#3036744-LU 504 N 85th St Recommendation Phase 11-24-2021 504 N 85th Apt LP

#### 1 MASSING OPTIONS

#### MUP Guidance:

EDG: Dayton Ave N

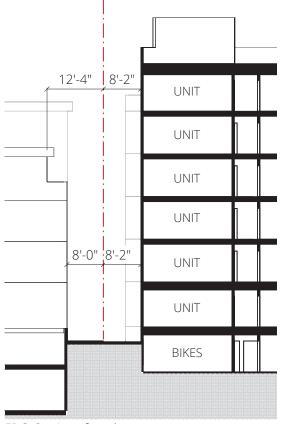
At EDG, Staff was concerned with the overall composition of the Dayton Ave N ground floor façade design. Recommended other means to unify the various disparate components on this elevation. Design this wall to provide texture, visual interest, and durable materials with minimal maintenance requirements.

At MUP, Staff recommended studying the window condition at the transformer vault.

The brick is brought down to grade, providing a human scale, high quality material at street level

planted with cast-in place planters and green screens

**RECOMMENDATION:** Section of northeast corner

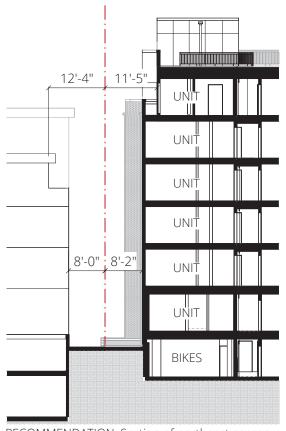
At EDG, Staff noted that the top floor setback that extends around to the north end of the west wing of the U-shaped mass successfully addressed the height difference with the adjacent existing structure. Staff recommended that the same setback should be applied to the northeast corner of the east wing of the U shaped mass U-shaped mass.

An upper-level setback was added to the NE corner of the east wing, reducing the height and mass facing the neighbors. This massing change also added two new private amenity decks at the level 7 units.

Section: Transformer Vault

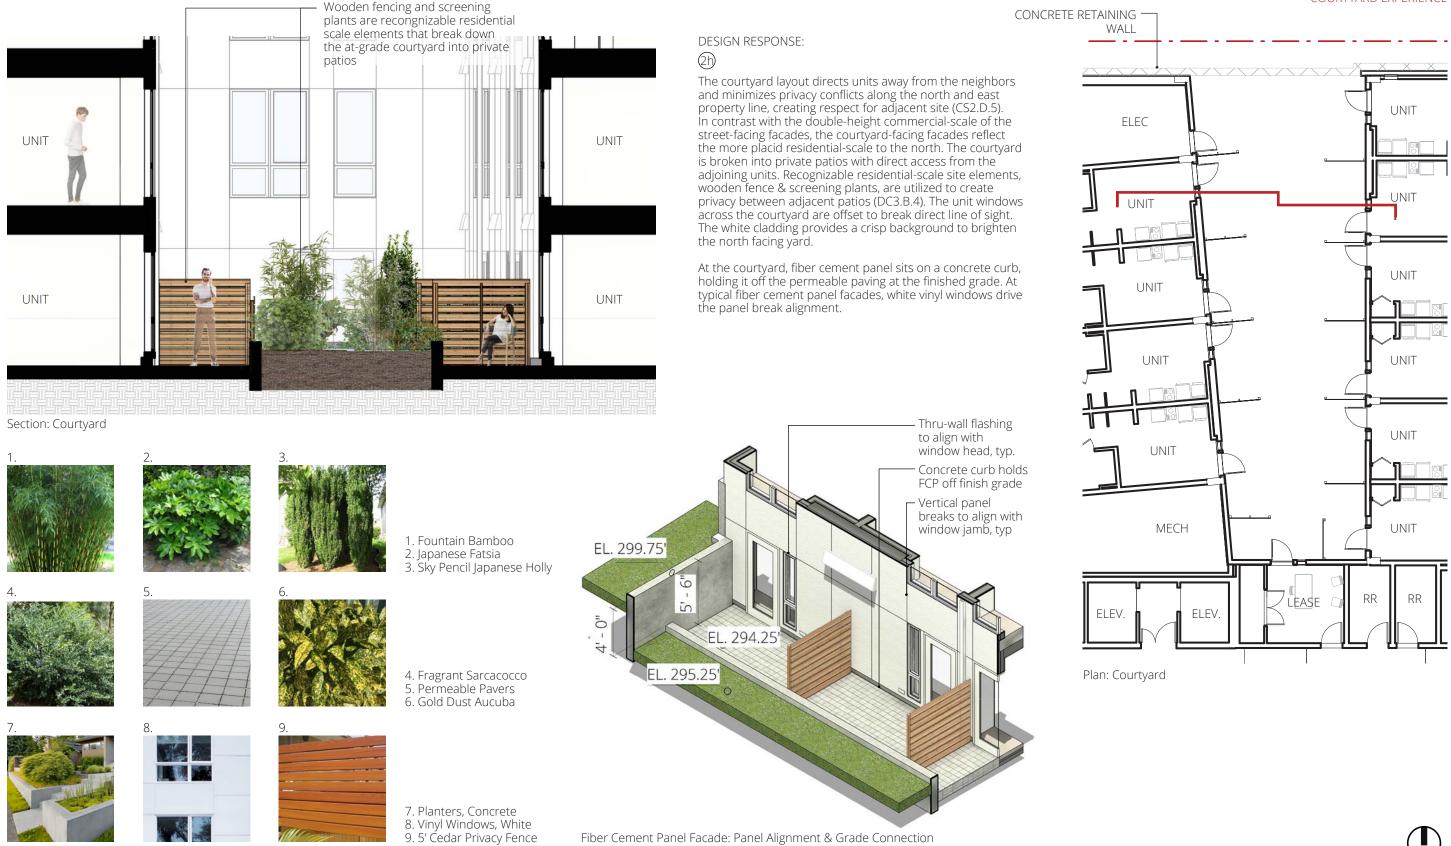
Correction #13. It is understood that a window is not provided on the second floor, at the north end of the west façade, because of the transformer vault, however, the blank wall condition does not work with the overall architectural composition. Study adding a black infill panel or other element to complete the rectangle. This will help alleviate the awkward condition below the soldier course.

The brick and fenestration pattern continue along the Dayton facade, but the service use doors break the stacks at the north end. Without an alley, the service uses are located along the secondary street, away from primary entries. (DC1.C.4) At the street level, landscape breaks down the blank wall and adds visual interest through layering of ROW planting, cast-in-place concrete planters, and wall mounted green screens.

#### 1. 23.47A.008.D.2: STREET LEVEL DEVELOPMENT STANDARDS

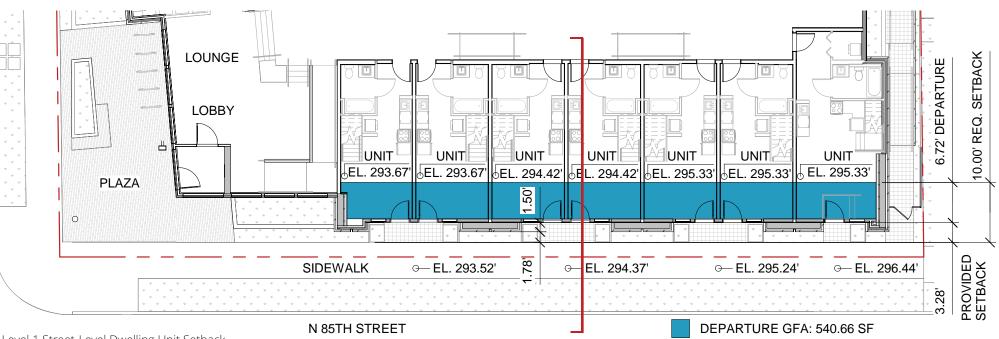
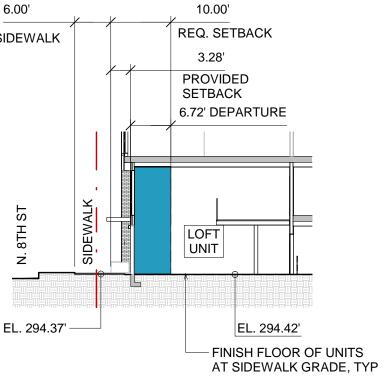
Staff preliminarily supports the setback departure; however, more study is required to achieve the proper setback and relationship to sidewalk grade. Although the proposed design has the potential to be well composed and fits with the overall architectural expression of the building, the design of the residential units as they relate to the sidewalk should be addressed first, and the potential conversion to retail, second. If the applicant follows guidance given in this report and explores increasing the distance from sidewalk as recommended, the design will better meet the Design Guidelines PL3-A-1-B (Entries), PL3-A-1-D (Entries), PL3-B-2 (Residential Edges), DC3-A-1 (Building open Space Relationship) and DC3-B-4 (Open Space and Activities).

In addition to the secondary architectural features and entry elements introduced at the street level, the unit entries were recessed 1'-6" from the primary building facade. The recesses creates relief and depth at the sidewalk for pedestrian circulation and resident entry.

#### 2. SMC 23.47A.008.A2: BLANK FAÇADE

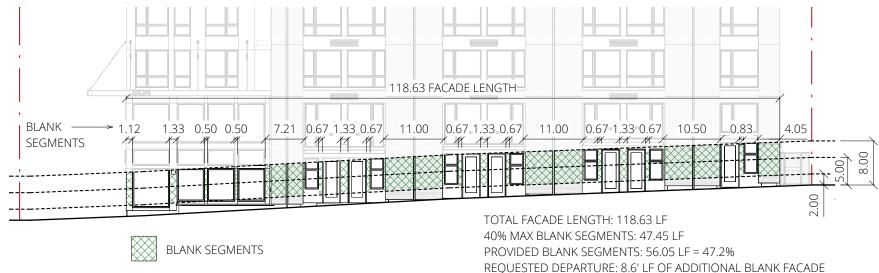
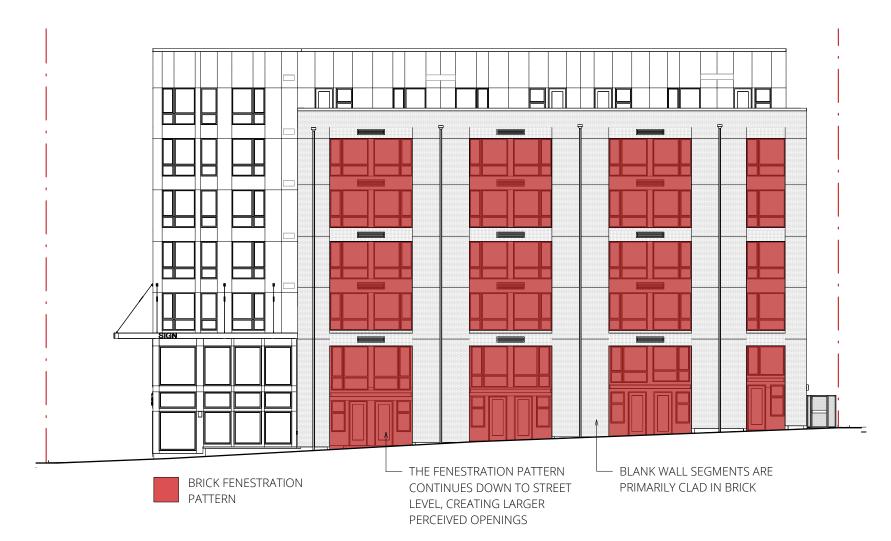
\*Mup correction triggered blank facade departure (Mullions and infill to be included in calculation)

- The recessed entries at the lofts add depth to the facade. The composition of elements in the recesses (windows/doors/mullions) read as one opening to reflect and stack with the fenestration composition above. Adding the mullions at the recesses into the calculation triggered the departure request.
- Most of the blank facade segments are composed of brick, a high quality, human scale material . that reflects the neighborhood aesthetic.
